Marulan Gas Turbine Facilities

Submissions Response & Preferred Project Report

May 2009

Date: 12 May 2009
Reference: 43177371/ 43177585
Status: FINAL

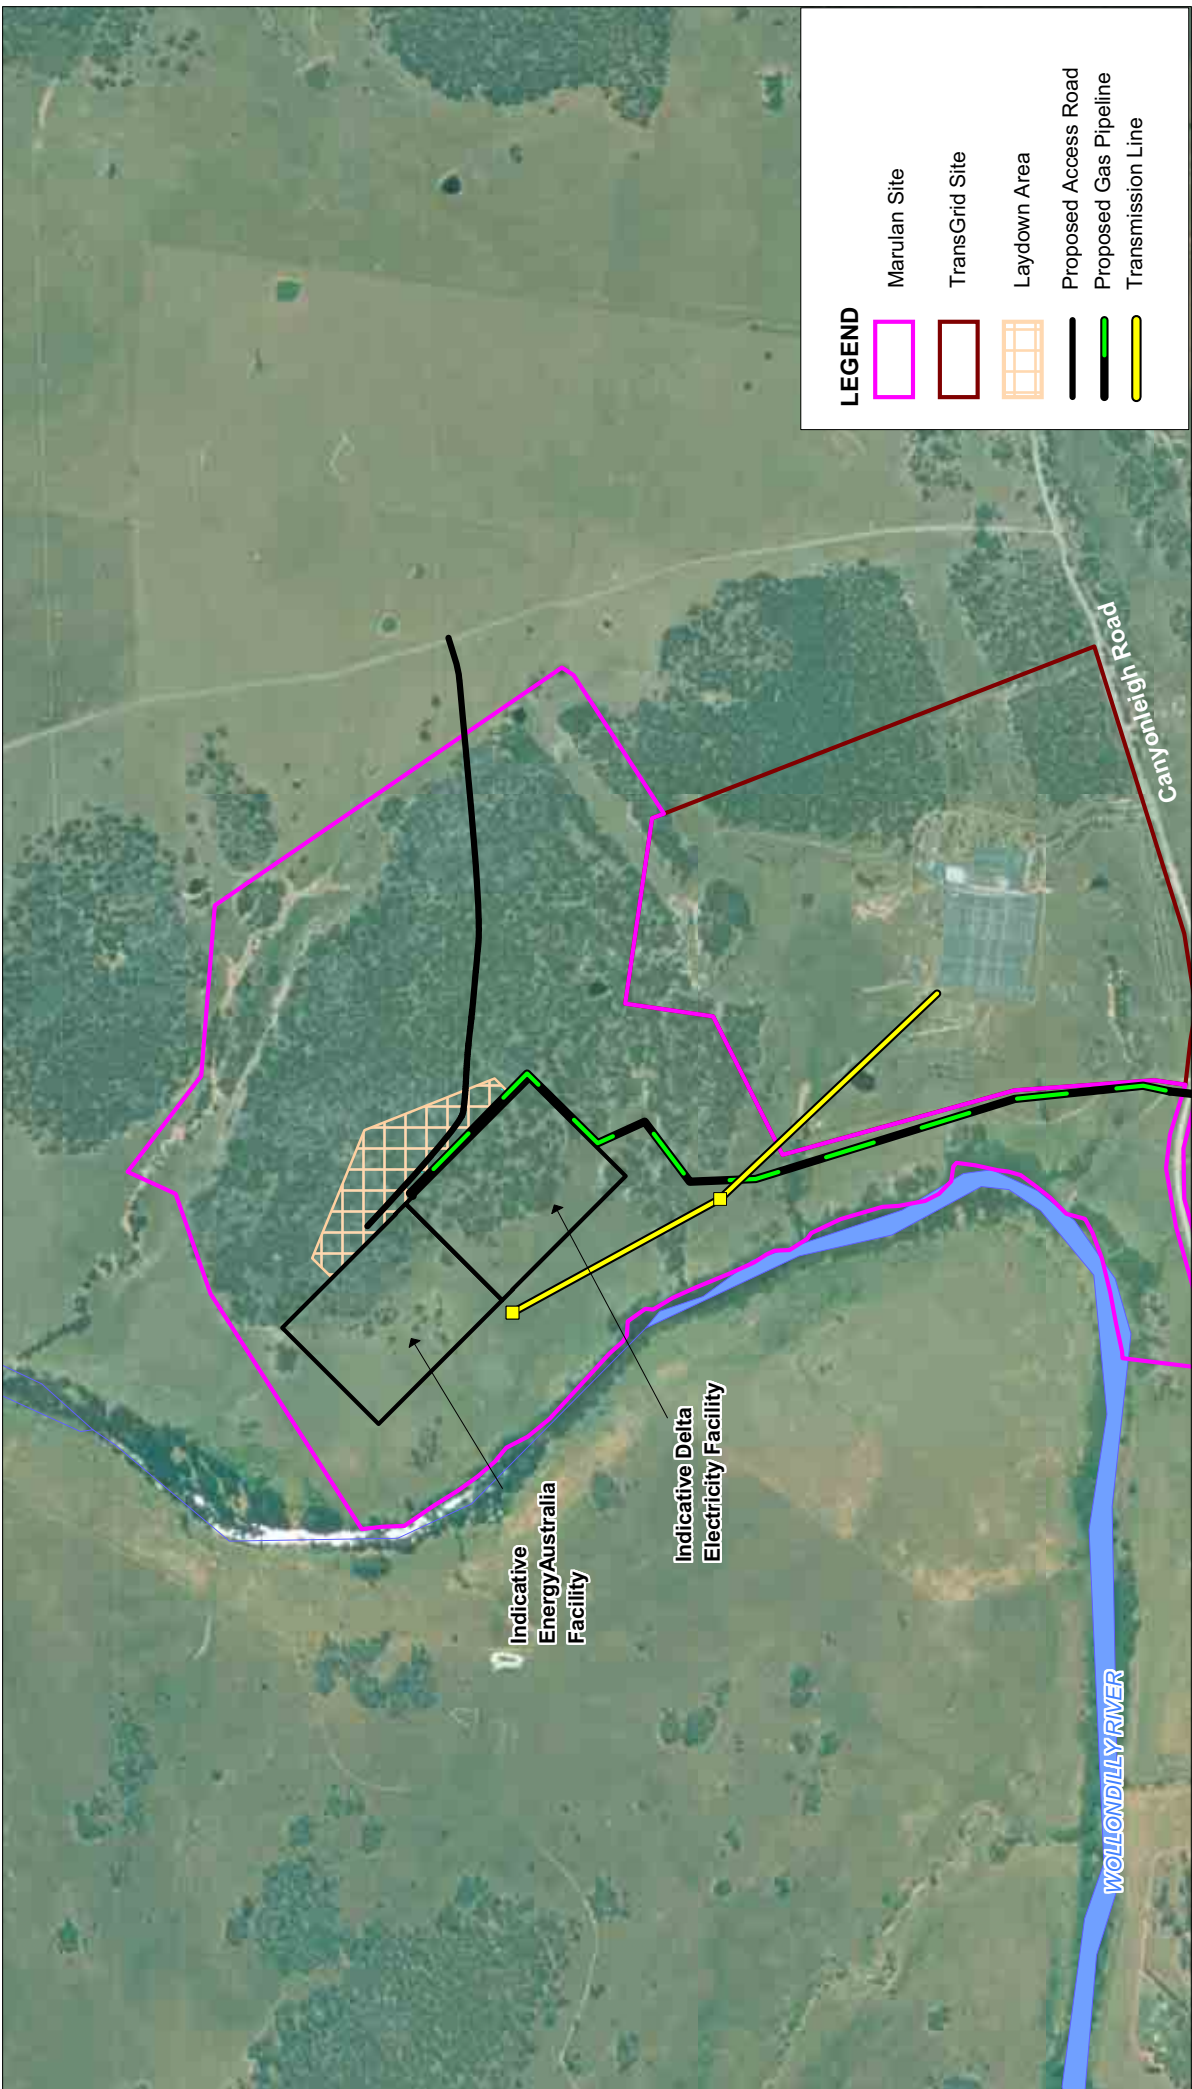
Further biodiversity assessment has been conducted on the Marulan Site and as a result, changes are proposed to the Facility infrastructure and footprint to minimise the area of clearing and avoid areas of high conservation significance. These are discussed in further detail in the Preferred Project Report (**Sections 4.6 and 4.7** of this Report). In summary, in order to avoid the areas of significant woodland within the Site, the following changes have been made:

Considering the cumulative effect of the above constraints as presented in Section 3.7 of the Joint Concept Environmental Assessment, the proposed location of the Facilities is in the area within the Marulan Site identified on **Figure 2-4** of this Report.

Considering the cumulative effect of the above constraints, the proposed location of the Facilities is in the area within the Marulan Site identified on **Figure 2-4** of this Report.

Figure 3-2 Illustration of Sound Pressure Levels

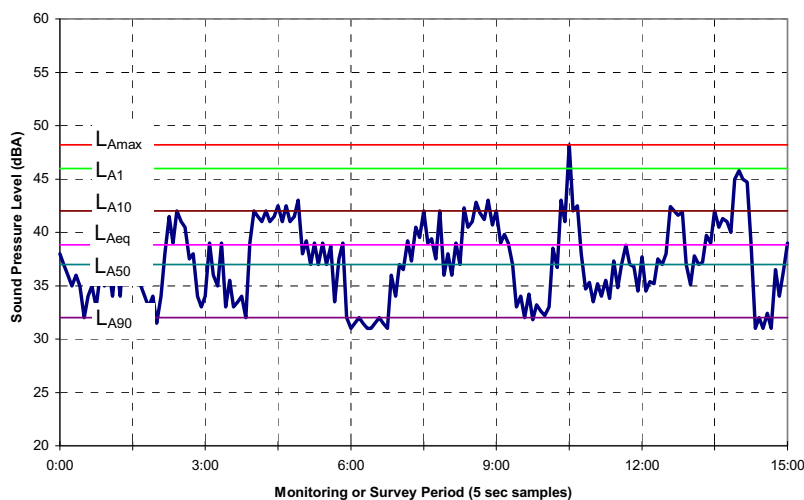
Submission 1.04: *I do not trust the figures quoted in regard to the level of ambient sound recorded and believe them to be excessive. Also, it is not appropriate to "average" sound levels over a long period as Gas Turbine noise output is constant and should be compared against the "quietest" time periods where it will be the most intrusive. Averaging does not accommodate for this. The noise from the operation of a Power Generating Facility, as proposed, is not compatible with this rural location.*

Consistent with the INP, long term unattended background noise measurements were conducted at four locations from Sunday, 7 May 2006 to Thursday, 18 May 2006 around the proposed Facility. The measured background noise levels analysed using the procedure presented in the INP varied between 27 and 31 dBA L_{A90} . The L_{A90} level is the noise level which is exceeded for 90 % of the sample period and can be referred to as the average minimum level. (Figure 3-2)

The project specific noise level of 35 dBA $L_{Aeq,15minutes}$ based on a 5 dBA above the lowest permissible RBL of 30 dBA as recommended within the INP is adopted for all residential receivers. This criterion is the most stringent criterion that can be developed by the procedures in the INP. As the residential receivers are rural, the criterion applies within 30 m of the existing residence.

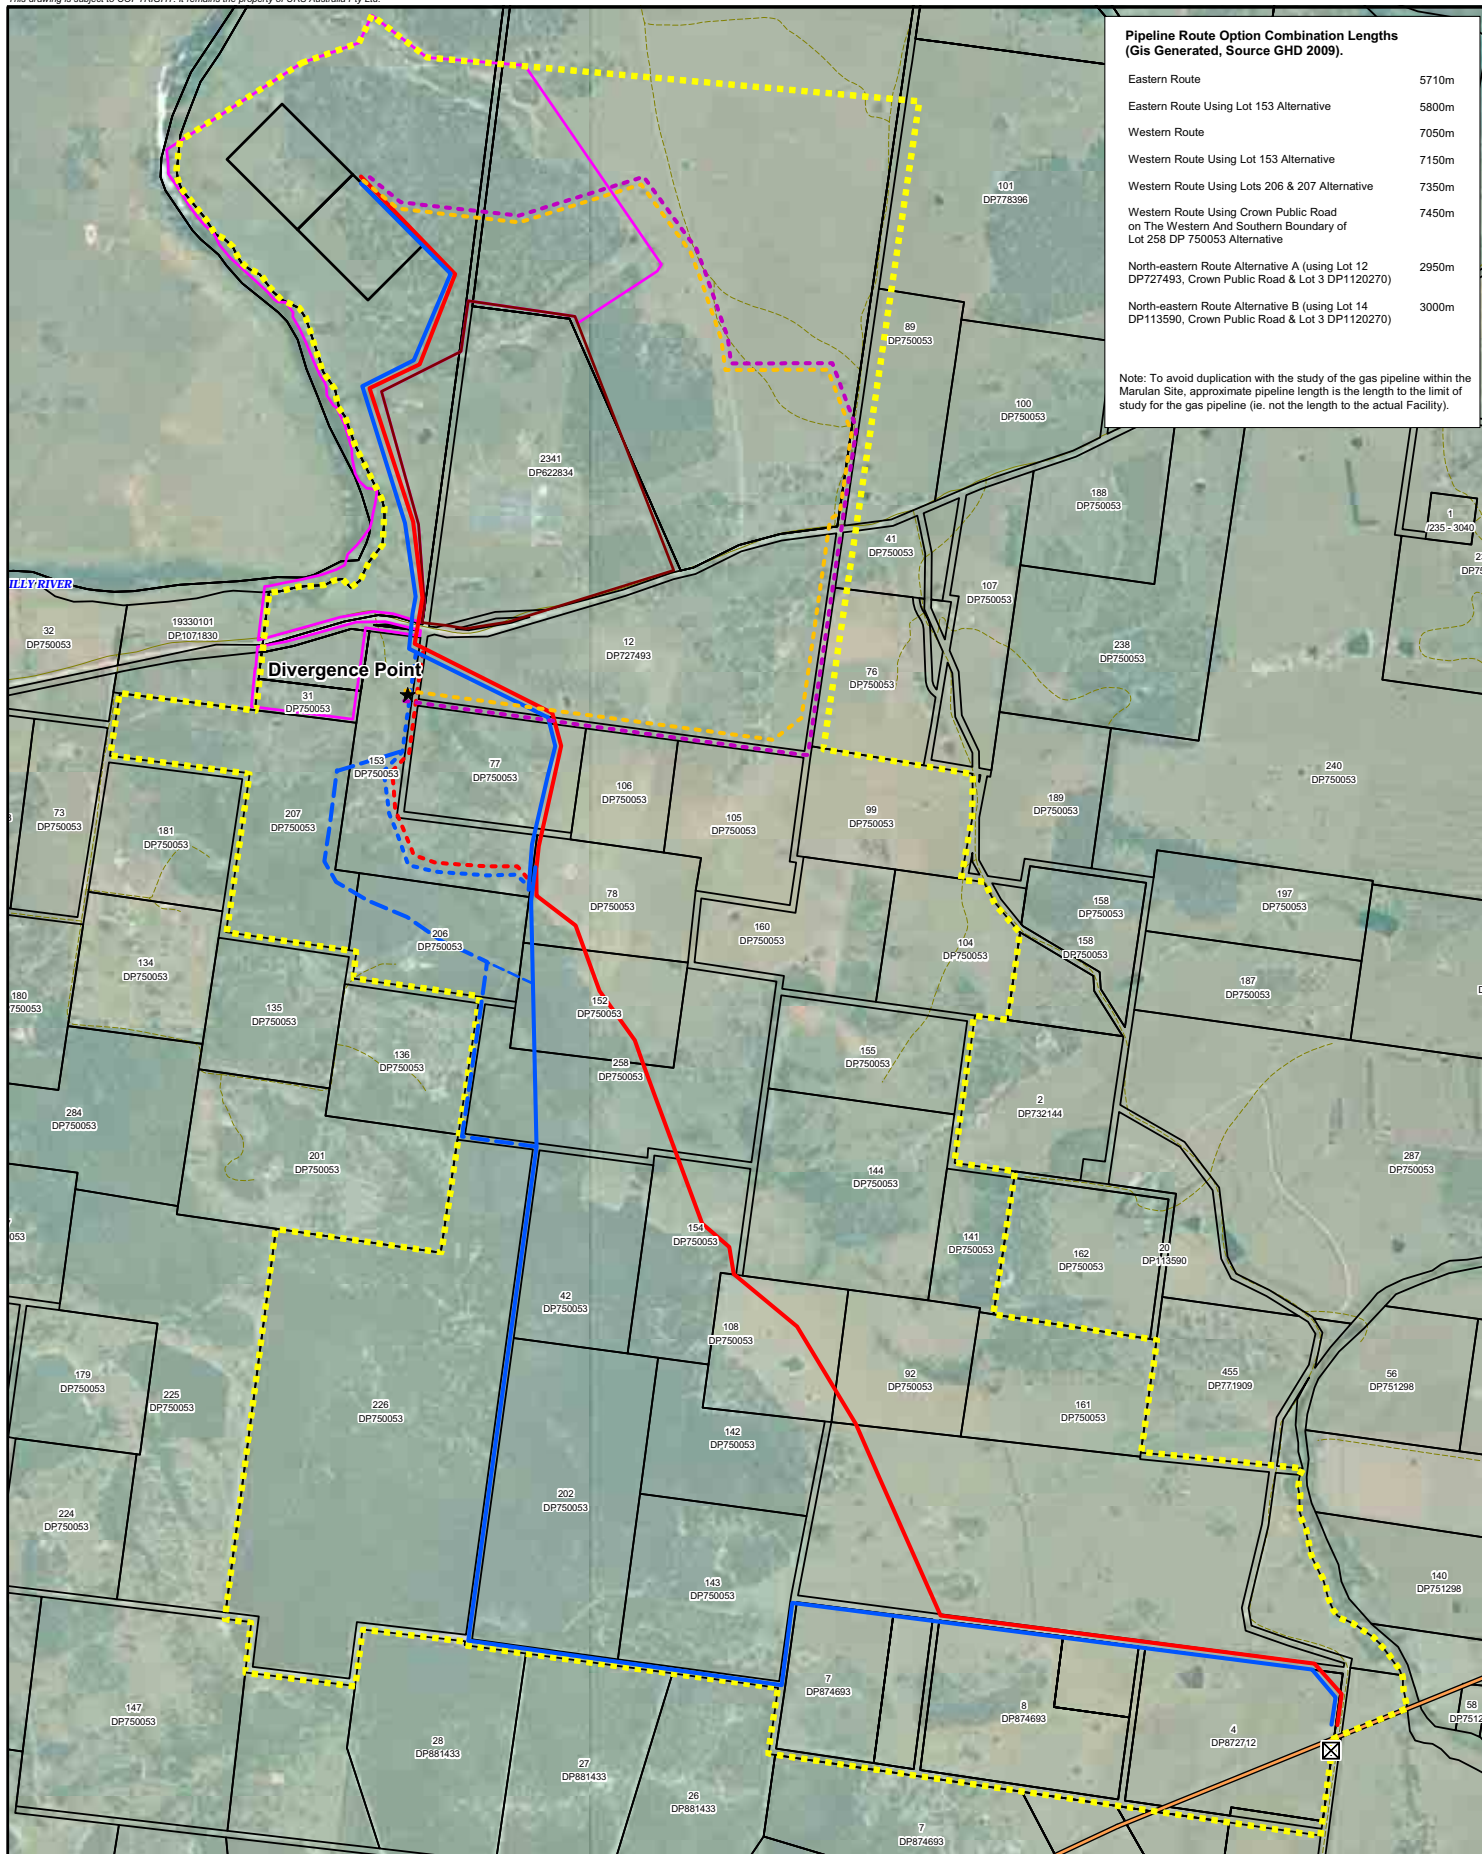
With this in mind, the Proponents aimed to review an alternative route, being the **Western** route as indicated in **Figure 4-4**. However, the **Western** route sits outside of the original identified concept corridor (Figure 4-9 of the Environmental Assessment and shown in **Figure 4-3** of this Report) and thus this Report also seeks to widen the corridor to include for assessment of this newly identified route.

Two more detailed pipeline route options were then developed in consultation with potentially affected land owners. These routes are known for the purposes of this Report, as the **Eastern** and **Western** routes as identified in **Figure 4-4**.

All of the permutations of the Western and Eastern Routes in combination with the North Eastern Routes total some 18 route options. **Table 4-7** provides a summary of the gas pipeline options. The route options are shown on **Figure 4-4**.

Figure: 4-7

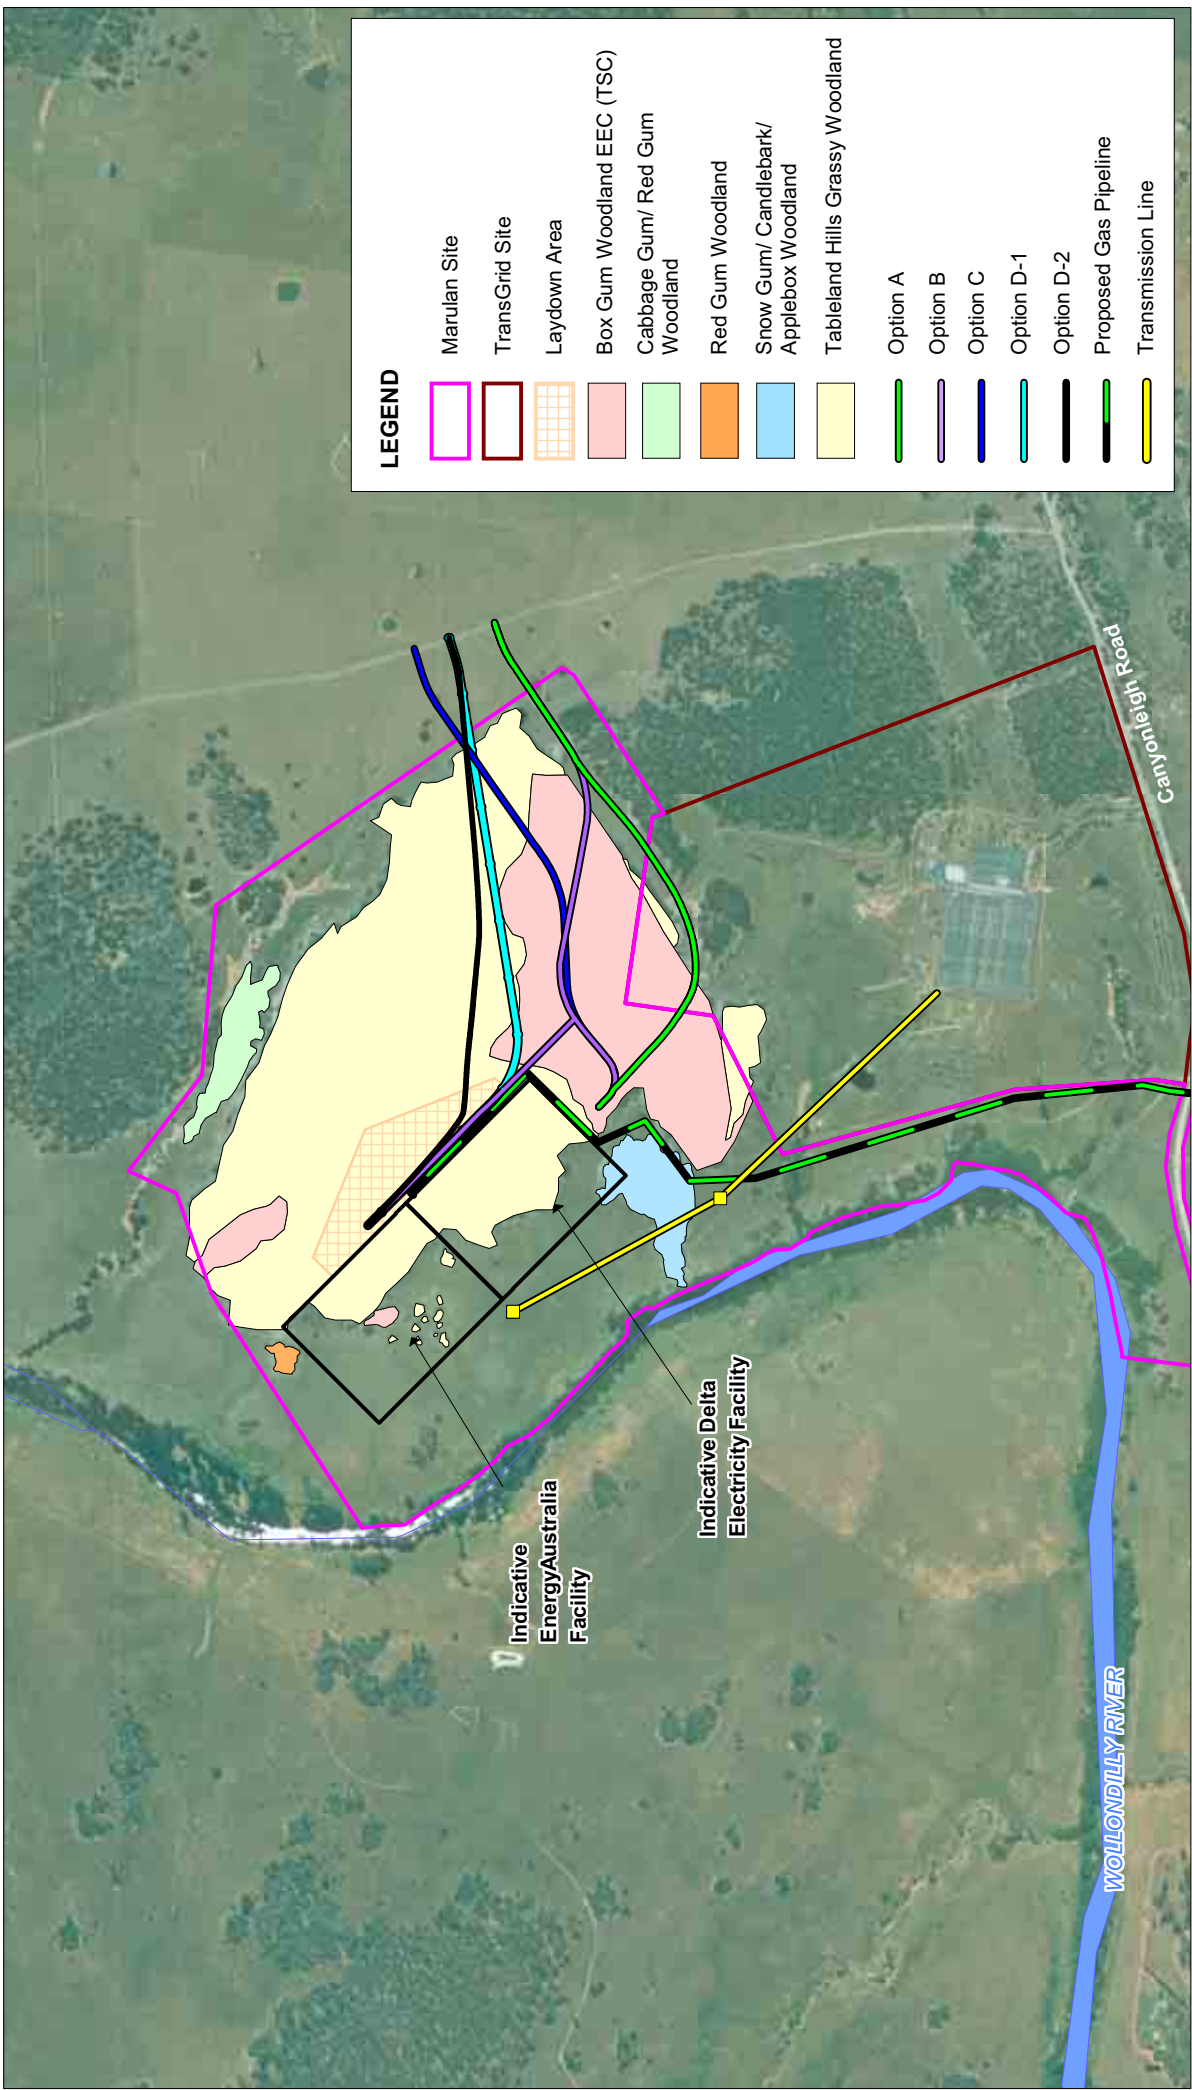
Based on the need to avoid the Box-Gum Woodland TSC EEC, the Proponent has committed to moving the southern boundary of the Facilities northward to avoid the Box-Gum Woodland TSC EEC. The proposed boundary presented in **Figure 4-7** does not intersect the mapped Box-Gum Woodland TSC EEC.

The revised pipeline route within the Marulan Site is presented on **Figure 4-7**.

The transmission line has been realigned to avoid fragmenting the Box-Gum Woodland TSC EEC. The revised transmission line route within the Marulan Site is presented on **Figure 4-7**.

It has been identified that illustrated figures in the Environmental Assessments did not present the entirety of the Marulan Site owned by the Proponent. A small area to the south of Canyonleigh Road was omitted from the Marulan Site boundary. This has been rectified and the correct boundary is presented in **Figure 4-7**.
